2. Alteration in position of wreck-marking buoy:—

No. 269 (first publication).—The following particulars, etc., relative to the above, issued by the British Admiralty (No. 1180 of 1920), are republished:—

WIRELESS METEOROLOGICAL INFORMATION TO AND FROM SHIPS AT SEA.

Reproduction of Portion of Chart No. 1235.

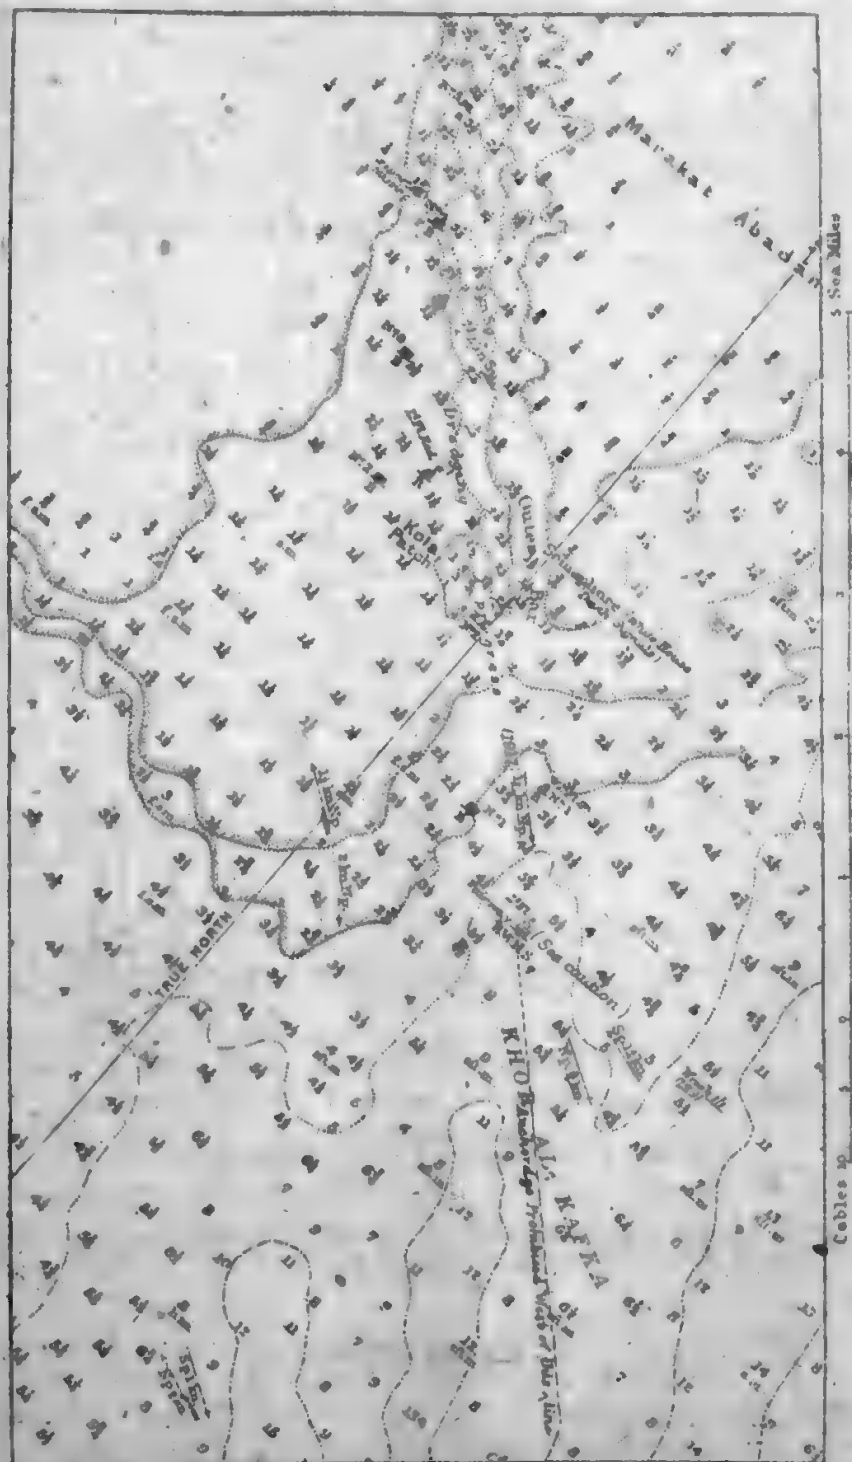
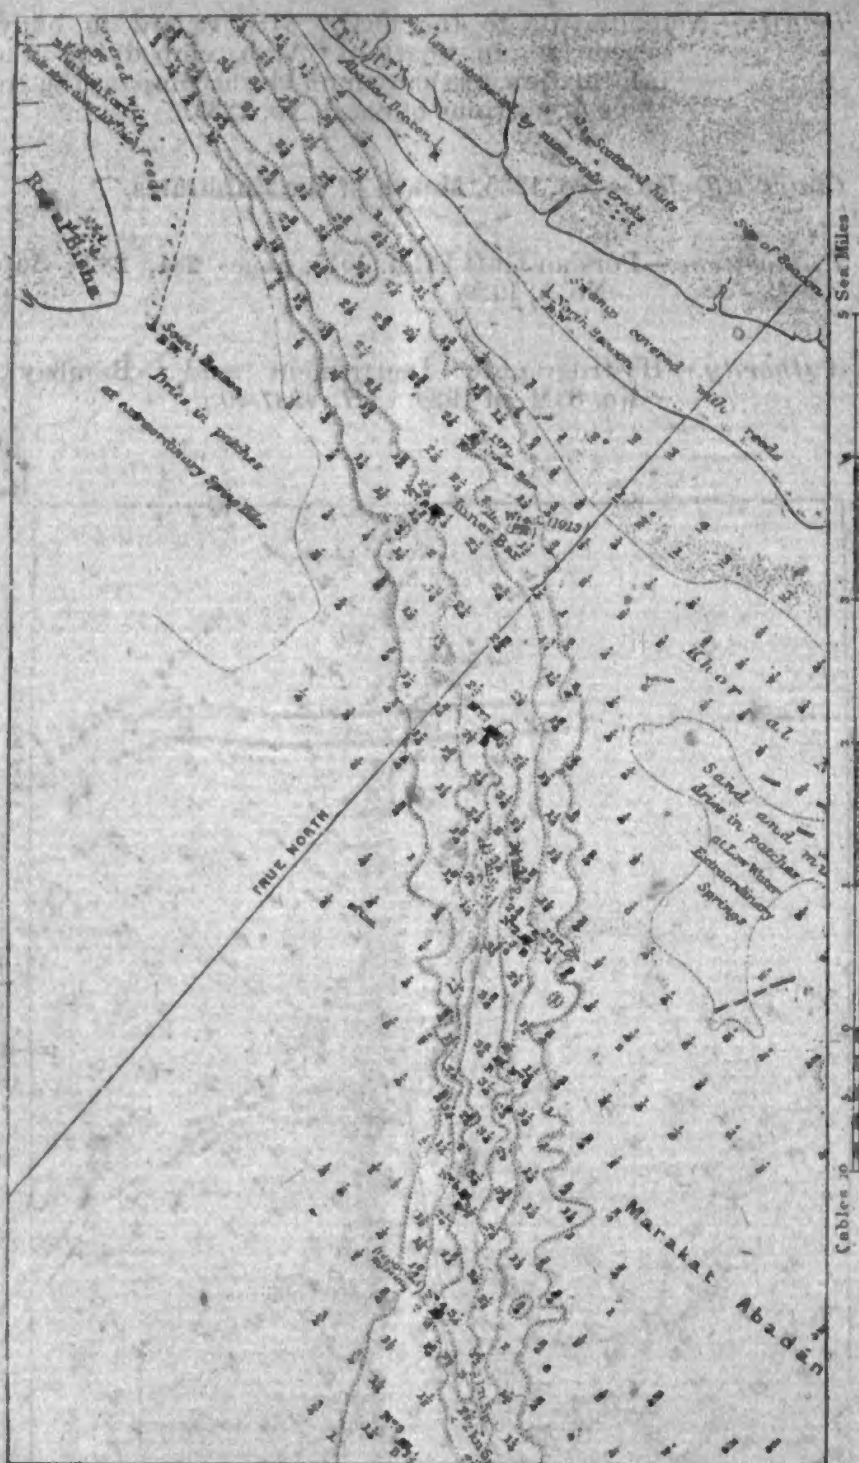
Chart affected.—No. 1235, Mouth of the Euphrates.
